**File #:** O-403-21      **Version:** 1      **Name:**

**Title:** Amending Toledo Municipal Code (TMC), Part Eleven, Subsection 1103.0207(B) and 1103.1519 regarding Downtown Parking Lot Fence Materials; and declaring an emergency.

**Amending Toledo Municipal Code (TMC), Part Eleven, Subsection 1103.0207(B) and 1103.1519 regarding Downtown Parking Lot Fence Materials; and declaring an emergency.**

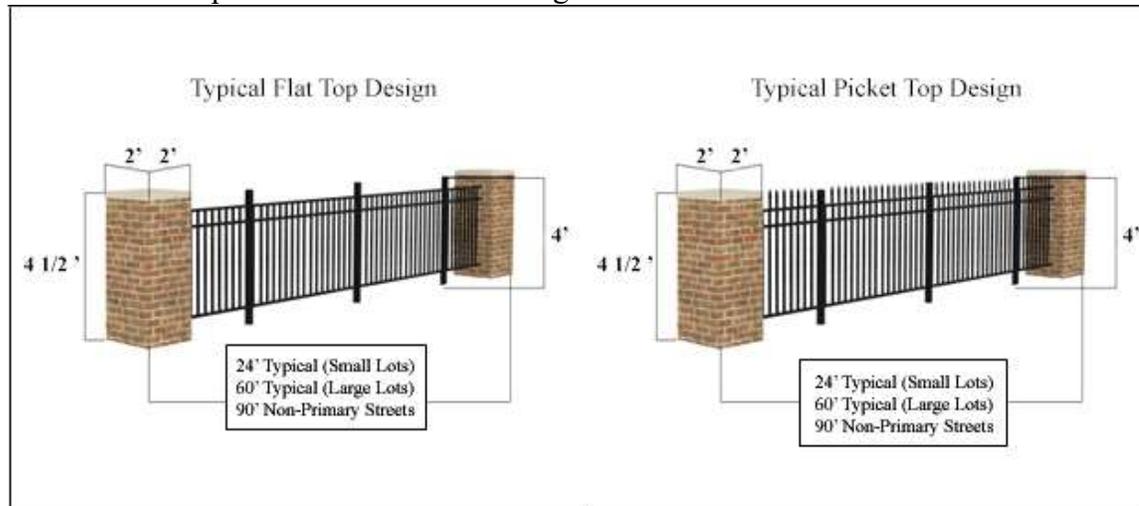
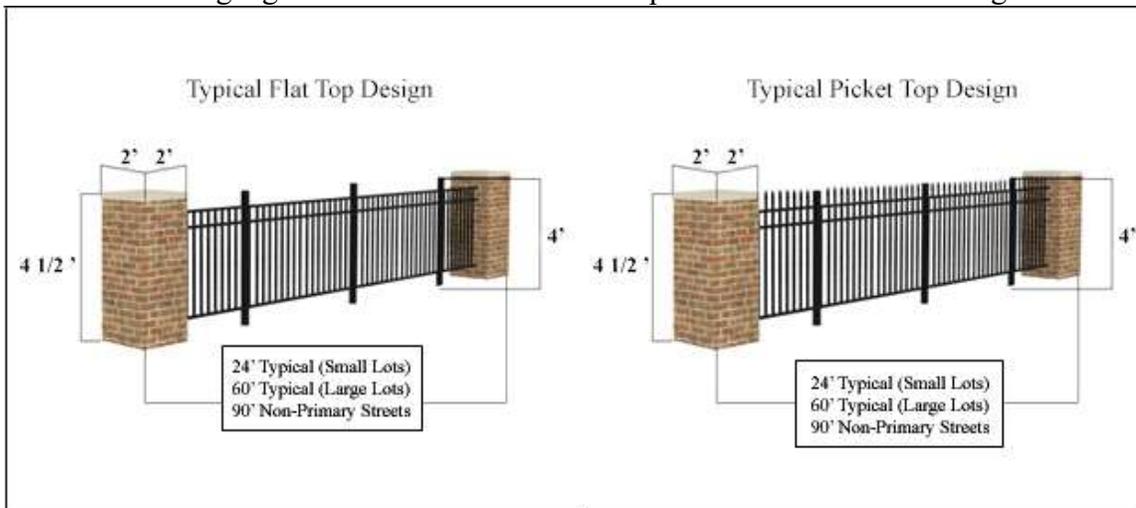
However, the existing language reads “Brick columns, or columns durably constructed with thin brick veneer are acceptable. Minimum acceptable product is a lightweight, high-density polyurethane material that is all weather and has the appearance of real brick that are equal to or better than the Carlton Brick Columns of Faux Panels.com/Barron Designs Incorporated.” Later, the fencing specifications read “Similar quality and look as Ultra Fencing & Railing’s UAF-200 Flat Top or Picket Top Commercial Series or Commercial Series Premium.”

Surface Parking Lots in the Downtown Overlay district shall be bordered along public rights of way by black wrought iron or black heavy gauge aluminum tube fencing that is at least four feet high with brick or thin brick columns that are at least 4’6” high and at least 18” wide or greater. Brick columns, or columns durably constructed with thin brick veneer are acceptable. Minimum acceptable product is a lightweight, high-density polyurethane material that is all weather and has the appearance of real brick that are equal to or better than the Carlton Brick Columns of Faux Panels.com/Barron Designs Incorporated. Columns shall be constructed using earth tone colors. On primary streets, spacing of columns shall be at least every 24’ for small lots (120’ x 120’ and under) and at least every 60’ for large lots (with frontage of more than 120’). On non-primary streets, spacing of columns may be spaced no more than 90’ apart. The Plan Director may approve greater distance spacing of columns where recommended by Toledo Downtown Parking Lot Review and Improvement Advisory Committee. Measurement as to placement of columns, new entrances, and exits will take into consideration turning radius needed for motor vehicles as well as two-way traffic. Fencing may connect to adjacent buildings rather than installing a pillar in instances where such connections are practical and do not detract from the purposes of this Chapter. The fences shall be clear of signage or other obstructions. The

**B.** Surface Parking Lots in the Downtown Overlay district shall be bordered along public rights of way by black wrought iron or black heavy gauge aluminum tube fencing that is at least four feet high with brick or thin brick columns that are at least 4'6" high and at least 18" wide or greater. Brick columns shall meet the requirements for brick as defined in Sec. 1109.0502.A. Columns shall be constructed using earth tone colors. On primary streets, spacing of columns shall be at least every 24' for small lots (120' x 120' and under) and at least every 60' for large lots (with frontage of more than 120'). On non-primary streets, spacing of columns may be spaced no more than 90' apart. The Plan Director may approve greater distance spacing of columns where recommended by Toledo Downtown Parking Lot Review and Improvement Advisory Committee. Measurement as to placement of columns, new entrances, and exits will take into consideration turning radius needed for motor vehicles as well as two-way traffic. Fencing may connect to adjacent buildings rather than installing a pillar in instances where such connections are practical and do not detract from the purposes of this Chapter. The fences shall be clear of signage or other obstructions. The specifications for the fencing are as follows:

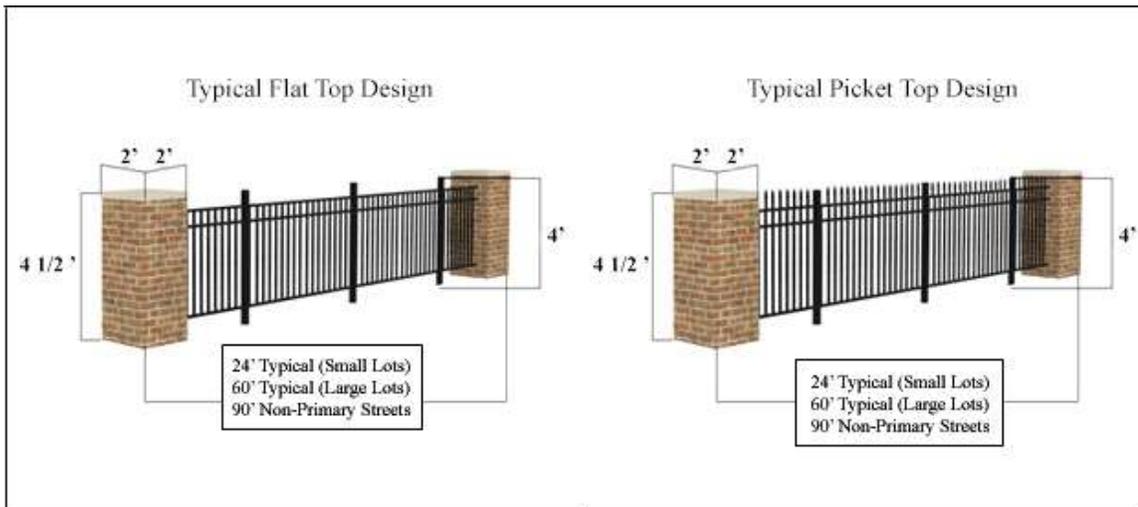
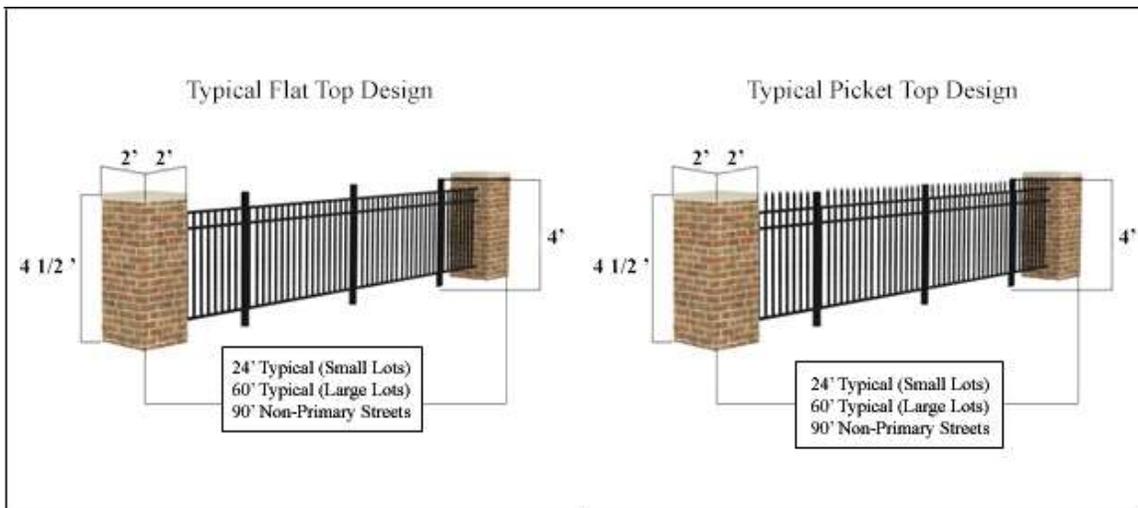
Surface Parking Lots shall be bordered along public rights of way by black wrought iron or black heavy gauge aluminum tube fencing that is at least four feet high with brick or thin brick columns that are at least 4'6" high and at least 18" wide or greater. Brick columns, or columns durably constructed with thin brick veneer are acceptable. Minimum acceptable product is a lightweight, high-density polyurethane material that is all weather and has the appearance of real brick that are equal to or better than the Carlton Brick Columns of Faux Panels.com/Barron Designs Incorporated. Columns shall be constructed using earth tone colors. On primary streets, spacing of columns shall be at least every 24' for small lots (120' x 120' and under) and at least every 60' for large lots (with frontage of more than 120'). On non-primary streets, spacing of

Surface Parking Lots shall be bordered along public rights of way by black wrought iron or black heavy gauge aluminum tube fencing that is at least four feet high with brick or thin brick columns that are at least 4'6" high and at least 18" wide or greater. Brick columns shall meet the requirements for brick as defined in Sec. 1109.0502.A. Columns shall be constructed using earth tone colors. On primary streets, spacing of columns shall be at least every 24' for small lots (120' x 120' and under) and at least every 60' for large lots (with frontage of more than 120'). On non-primary streets, spacing of columns may be spaced no more than 90' apart. The Plan Director may approve greater distance spacing of columns where recommended by Toledo Downtown Parking Lot Review and Improvement Advisory Committee. Measurement as to placement of columns, new entrances, and exits will take into consideration turning radius needed for motor vehicles as well as two-way traffic. Fencing may connect to adjacent buildings rather than installing a pillar in instances where such connections are practical and do not detract from the site.
